THE ELECTRICAL DISTRIBUTION SWITCHGEAR

THE RUTHERFORD LABORATORIES

7 GeV PROTON SYNCHROTRON

ELECTRICAL SWITCHGEAR.

FIGURE 1.

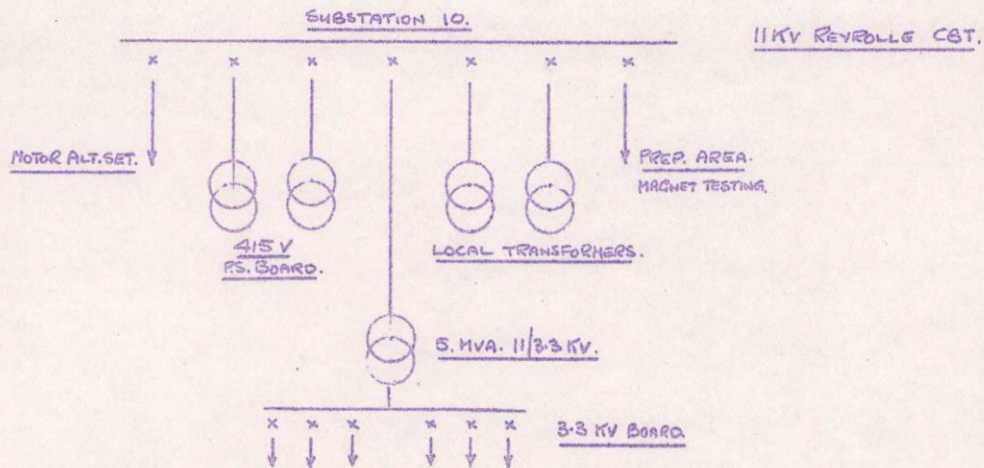
Figure 1 is a single line diagram shewing the layout of 11 KV and 3.3 KV switchgear (a) as envisaged in November 1957 and (b) as proposed now.

- i) Due to the large pulsating load involved and to keep the system voltage variations within tolerable limits, it is now proposed to supply the main power requirements of the P.S. from its own 132/11 KV 20 MVA Grid transformer. This necessitates the provision of a new 11 KV switchboard.
- ii) Two main drive motors are being installed, each supplied with its own 11 KV feed.
- iii) Two rectifying equipments provide a D.C. supply for the excitation of the alternators. Each rectifying equipment has its own 11 KV supply.
- iv) The alternator ventilation fans are fed from a separate 11/0.415 KV transformer.
- v) Two 11 KV supplies from substation 10 have been installed for magnet testing.

Apart from the provision of a separate 11 KV switchboard, there is an increase of 6 11 KV switch units, one of which will be supplied by the G.E.G.B., The extra cost is estimated at £13,000.
